Technical Service Bulletin: TSB150153 Released Date: 16-Oct-2018

Fault Code 3314, 3317, 3319, 3146 or 4518 Caused by Aftertreatment Exhaust Gas Temperature Sensor Malfunction

Figure 1, Date Code Location on the Aftertreatment Exhaust Gas Temperature Sensor.

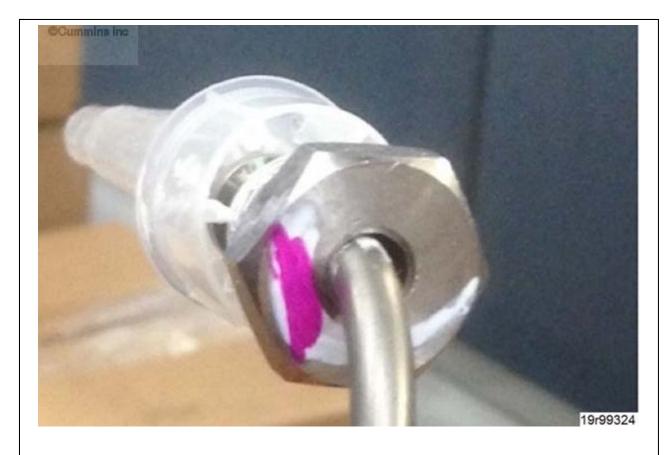
If the aftertreatment SCR exhaust gas temperature sensor or the aftertreatment DPF exhaust gas temperature sensor requires replacement, the new aftertreatment exhaust gas temperature sensor **must** be inspected prior to installation. See Table 1 below.

Table 1, Aftertreatment Exhaust Gas Temperature Sensor Inspection Criteria			
Part Description	Date Code On Sensor Body ¹	Markings ²	Action
Aftertreatment Exhaust Gas Temperature Sensor	20150730 and before	No marking	Do not use
	20150730 and before	White half circle and a pink line on the hexagon nut	OK for use
	20150514 and before	Two white lines on side of housing	OK for use
	20150730 and before	White half circle on the hexagon nut	OK for use
	20150730 and before	White half circle with pink dot on the hexagon nut	OK for use
	20150730 and before	White dots on sensor body	OK for use
	20150731 and after	No marking or two parallel white bars on the hexagon nut	OK for use
¹ See Figure 1 Below	/. ² See Figure 2 and Fig	ure 3 Below.
